PERKINS, BLAINE, 10/11/2024 8:33 AM

FLYING HORSE NORTH FILING NO. 5 PUD PRELIMINARY PLAN A MINOR AMENDMENT TO THE 2016 FHN PUD

PUD PRELIMINARY PLAN MINOR AMENDMENT
COVER

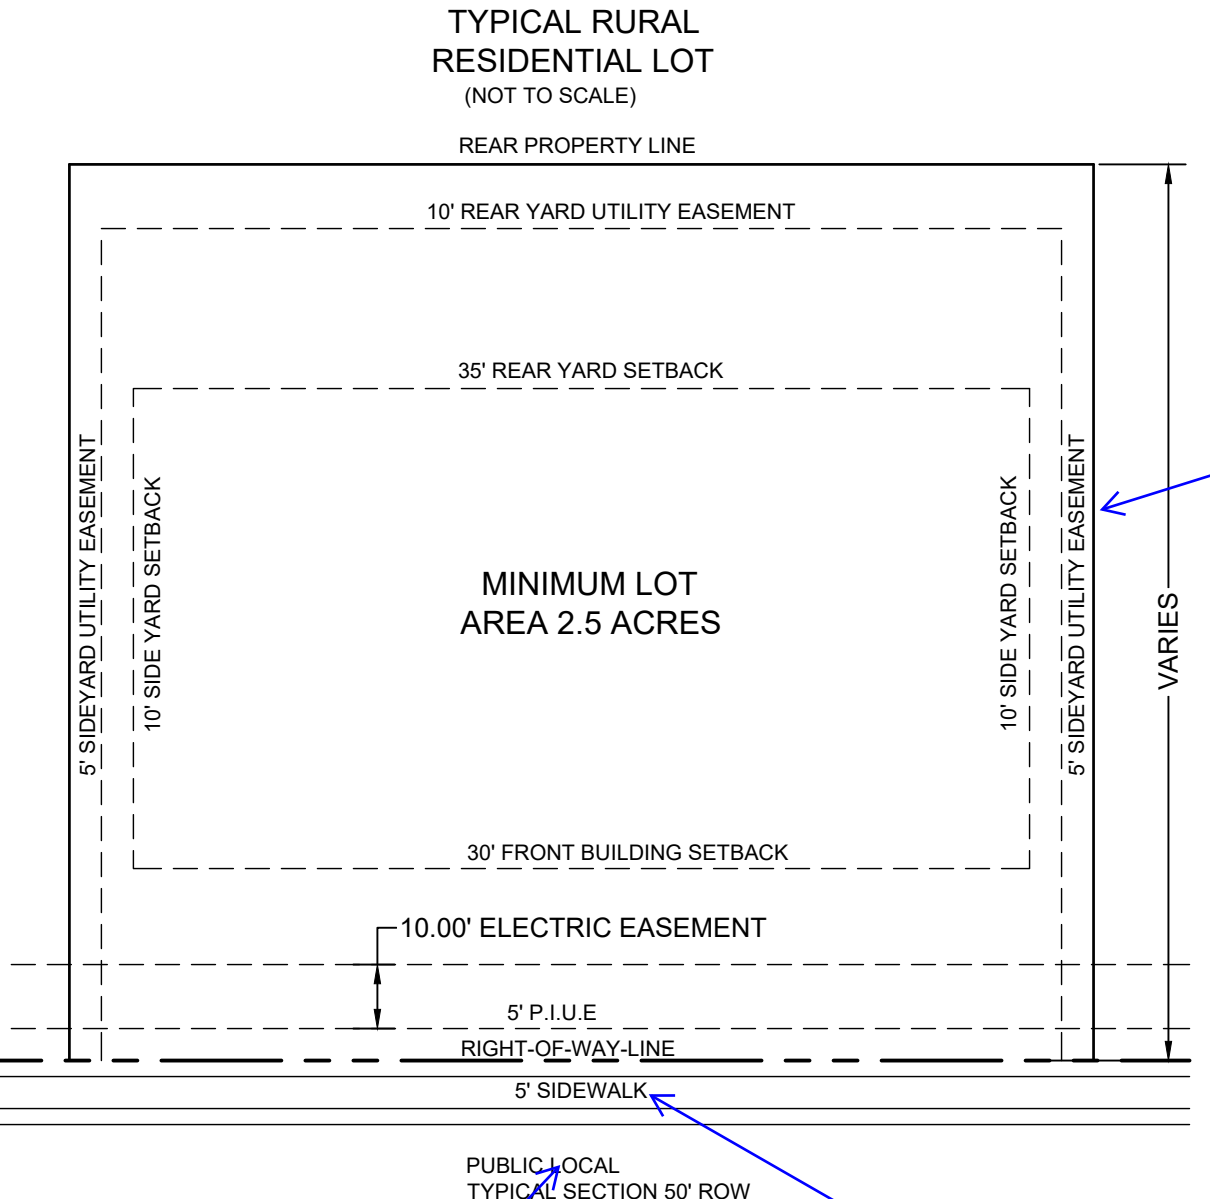
Identify the side lot drainage easement proposed

add: and/or approved with a deviation request by the ECM administrator

rural local

sidewalks are not provided on rural local roadways. Revise.

60' per the prelim plan, revise accordingly
